UNITED STATES PATENT AND TRADEMARK OFFICE

APPLICATION NO.	FILING DATE	FIRST NAMED INVENTOR	ATTORNEY DOCKET NO.	CONFIRMATION NO.
10/789,120	02/27/2004	Thomas Bader	DT-6776	7611
30377	7590	12/02/2005	EXAMINER	
DAVID TOREN, ESQ. ABELMAN FRAYNE & SCHWAB 666 THIRD AVENUE NEW YORK, NY 10017-5621			SHAKERI, HADI	
			ART UNIT	PAPER NUMBER
			3723

Office Action Summary

DETAILED ACTION

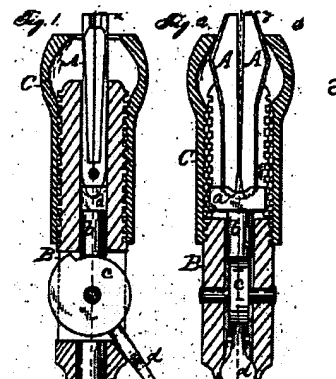
5. Claim 1 (as best understood) is rejected under 35 U.S.C. 102(b) as being anticipated by Armstrong (307,252).

Armstrong discloses all of the limitations of claim 1, i.e., a device (A, B, C) capable of being securable on a shaft supporting tool bit for holding a bit insertable in the tool bit of a power tool comprising at least two clamping members (A, A) displaceable upon application of a force from a holding or support position to a release position and forming a front stop (tip projecting out of C).

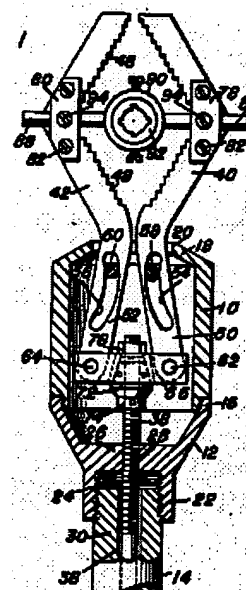
6. Claims 1, and 4-6 (as best understood) are rejected under 35 U.S.C. 102(b) as being anticipated by Stevens (2,704,003).

Stevens discloses all of the limitations of claim 1, i.e., a device (10, 40, 42) capable of being securable on a shaft supporting a tool bit for holding a bit insertable in the tool bit of a power tool comprising at least two clamping members (defined by 48 of 40, 42) displaceable upon application of a force (through rotation of crank 34) from a holding or support position to a release position and forming a front stop (tip of 46).

Regarding claims 4-6, Stevens meets the limitations, i.e., clamping arms (50, 52) supported by a pivot support (62, 64) displaceable by a slotted crank guide (54, 56); the guide having a curved recess and a guide member (58, 60) connected to the shaft (24, thru 12) and having curved first end in the support position.

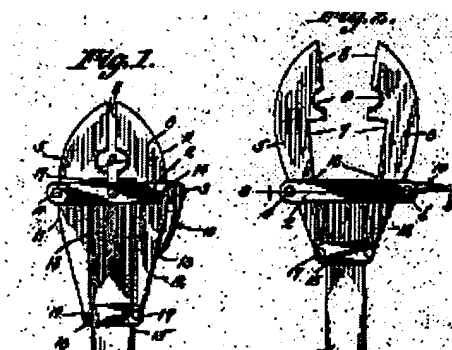
7. Claims 1, 10, and 11 (as best understood) are rejected under 35 U.S.C. 102(b) as being anticipated by Beaver (1,623,379).

Beaver discloses all of the limitations of claim 1, i.e., a device (2, 5, 6, 15) capable of being securable on a shaft supporting a tool bit for holding a bit insertable in the tool

bit of a power tool comprising at least two clamping members (defined by 9 of 5, 6) displaceable upon application of a force from a holding or support position to a release position and forming a front stop (tip of 8).

Regarding claims 10 and 11, Beaver meets the limitations, i.e., a locking device (10) and means for adjusting the locking position (12, 13). Note that narrative/function language fails to further limit the device structurally.
